U1604B-01

**S E R V I C E N O T E**

U1604B Handheld Oscilloscope

**BNC cable cannot secure oscilloscope input channel**

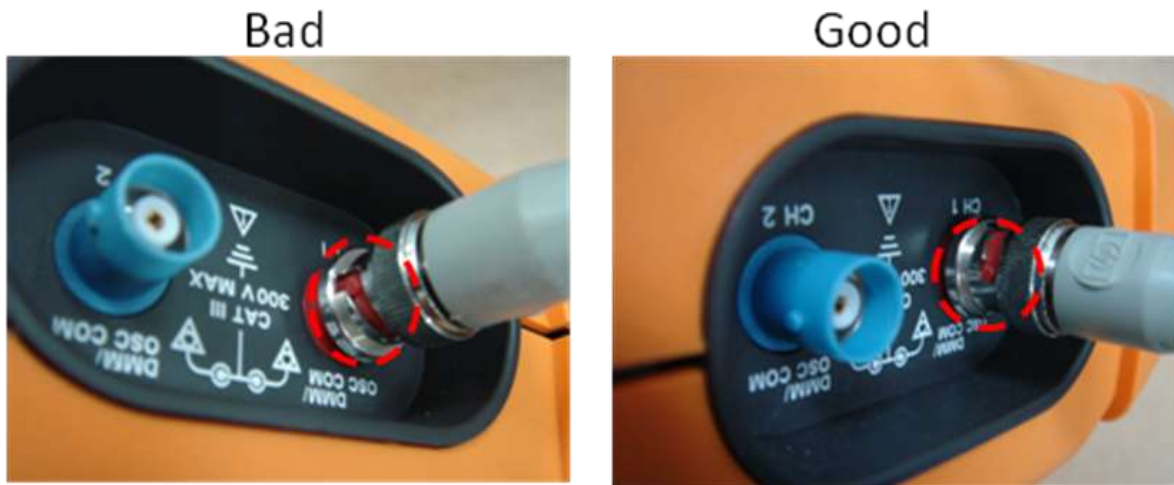
**Situation:**

If customer report about BNC connection cannot lock at Handheld Oscilloscope BNC connect. Please refer to picture below:

**Solution/Action:**

1. Verify customer unit with Agilent BNC cable or Agilent BNC connector (1250-0256)
2. If verification failed, please provide unit exchange with customer.
3. If verification passed, please inform customer the BNC connector is meeting spec and no action required from SSU.
